DFCM Addendum #1

Reference: Brigham City Rest Area Landscape Upgrades

DFCM Project #25108900 U3P Event #CS25010

ADDENDUM #01

DEMOLITION

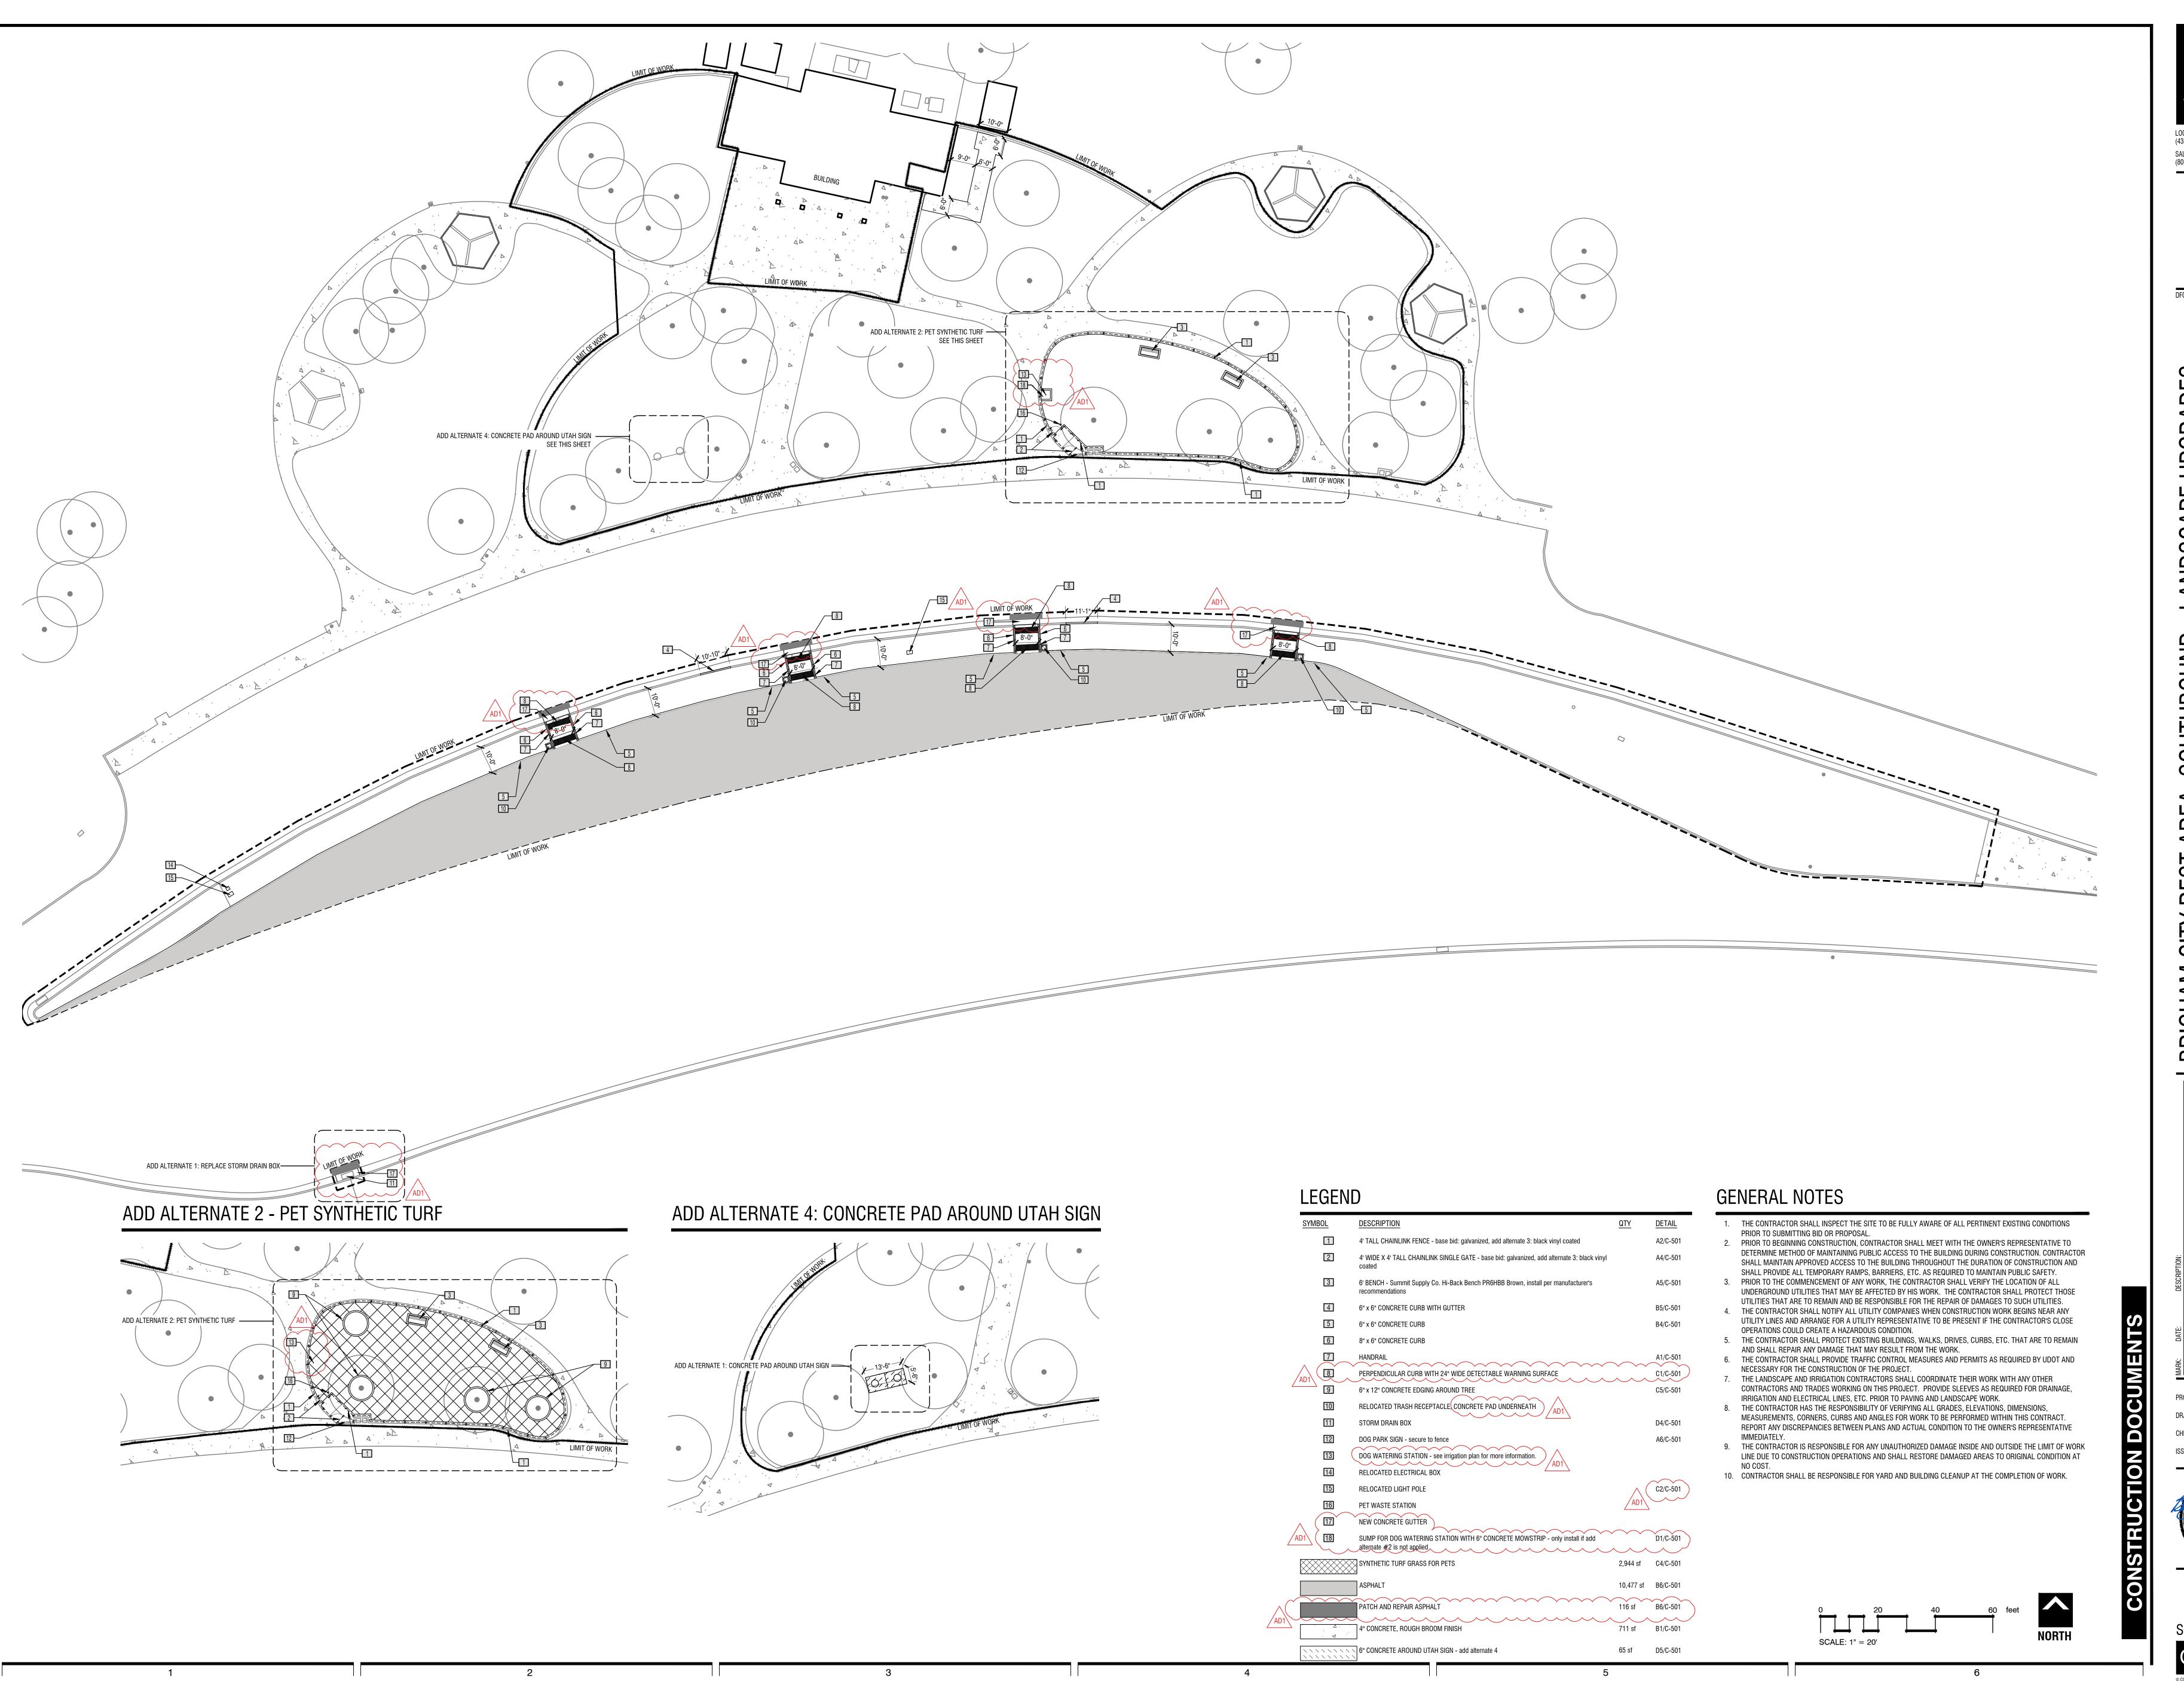
C-001 – Demolition Plan

- Added note D-17: SAWCUT GUTTER
- Added note D-17 to each new curb cut location as well as note D-01: Sawcut curb.
- Added note D-17 to Add Alternate 1 around the storm drain box.

SITE DETAILS C-501

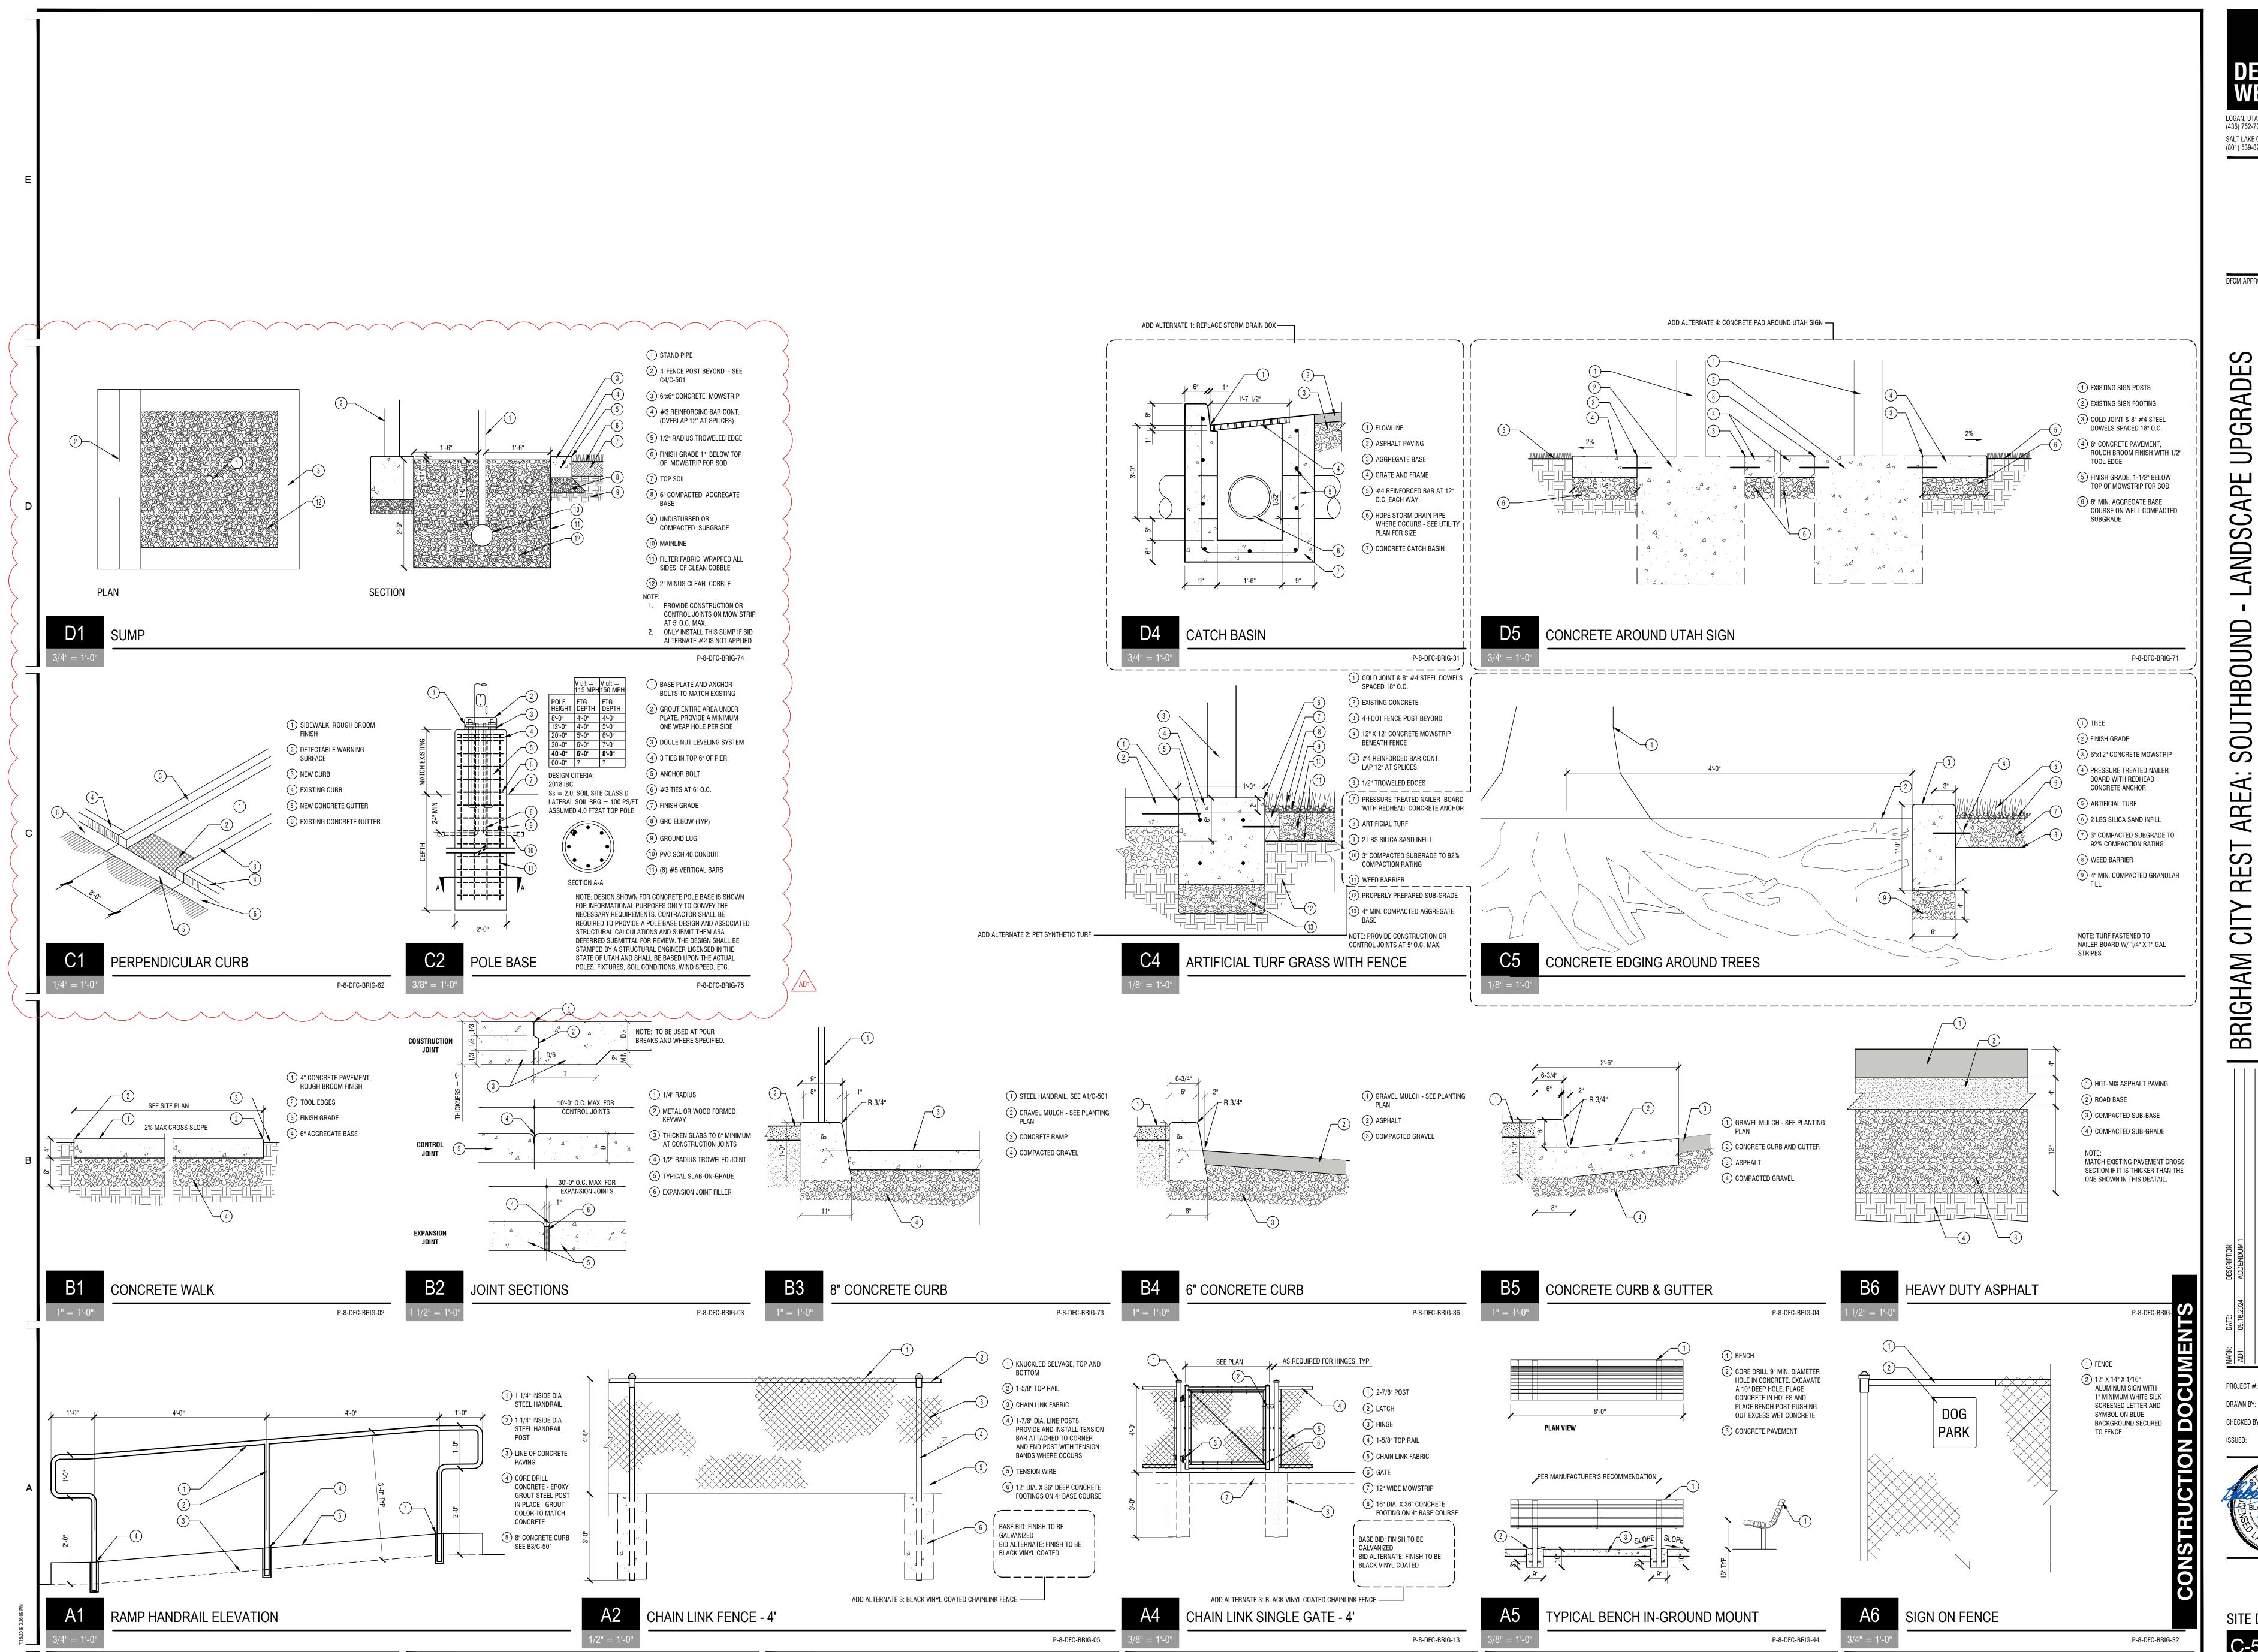
C-501 - Site Details

- Added details:
 - o C1: Perpendicular curb ramp
 - o D1: Sump
 - C2: Light pole base

- 4. Anchor bolts for relocating light poles: Reuse existing anchor bolts if possible. If not, provide new anchor bolts of the same size. See detail C2/C-501 for light pole base detail.
- 5. See D-06 and D-13 on Sheet C-001.
- 6. No asphalt striping or curb painting will be part of this project.
- 7. See notes 13 and 18 on C-101. See D1/C-501 for sump detail (only install sump if add alternate 2 is not applied) See valve 5 on L-201. See legend for Rain Bird PEB Valve for Dog Watering Station and Hose Bib.
- 8. See note 10 on C-101.
- 9. See detail C2/C-501 for light pole base detail.
- 10. See the following hatch on C-001:
